UNITED STATES PATENT AND TRADEMARK OFFICE

Office Action Summary	Application No.	Applicant(s)	
	10/813,228	BENEDICT ET AL.	
	Examiner	Art Unit	
	GREGORY W. ADAMS	3652

DETAILED ACTION

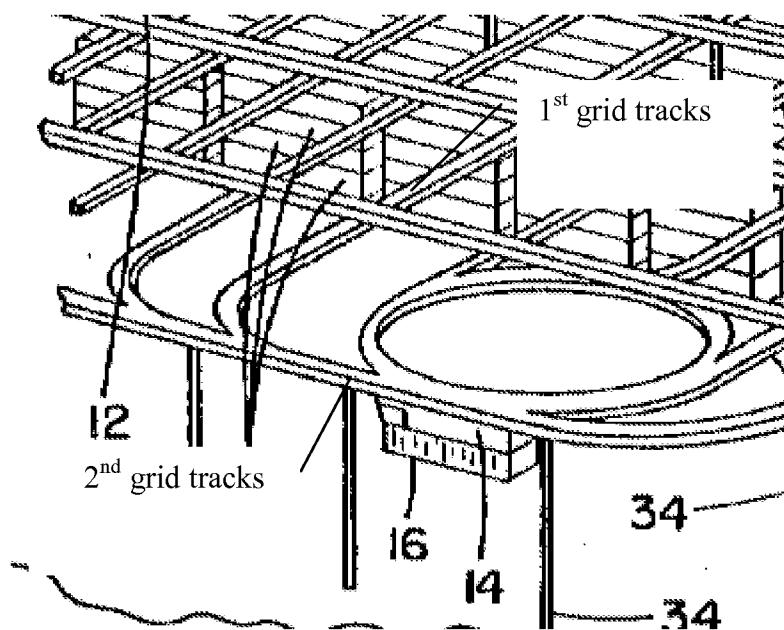
- grid first tracks intersecting with second grid tracks (see FIG. 1 reproduced below)
- transfer unit 14 suspended from a grid track system
- a plurality of carriage means (indicated generally as 44) suspending a transfer unit
- transfer unit drive means 54
- spreader beam 40
- hoist means 55
- guide member 42
- means (C18/L30-45) for providing electrical power to a drive means.

Brickner does not disclose first pairs of parallel tracks and second pairs of parallel tracks in an X-Y pattern. Yamashita discloses first pairs of parallel tracks 2, 3 and second pairs of parallel tracks 4, 5 in an X-Y pattern "for use in building warehouses" for

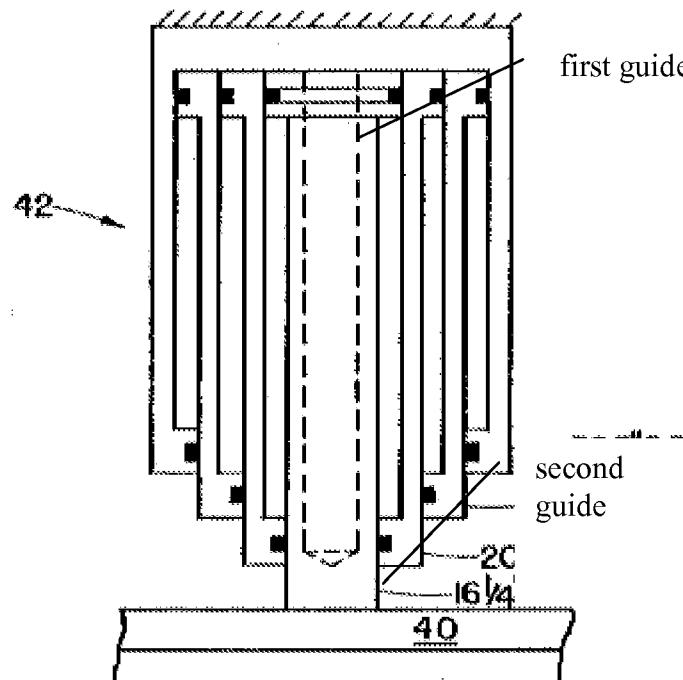
With respect to claims 7 & 18, Brickner et al. disclose a first guide member mounted to a transfer unit and a second guide member mounted to a spreader beam 40 a guide member comprising arms. See FIG. 9 reproduced below.
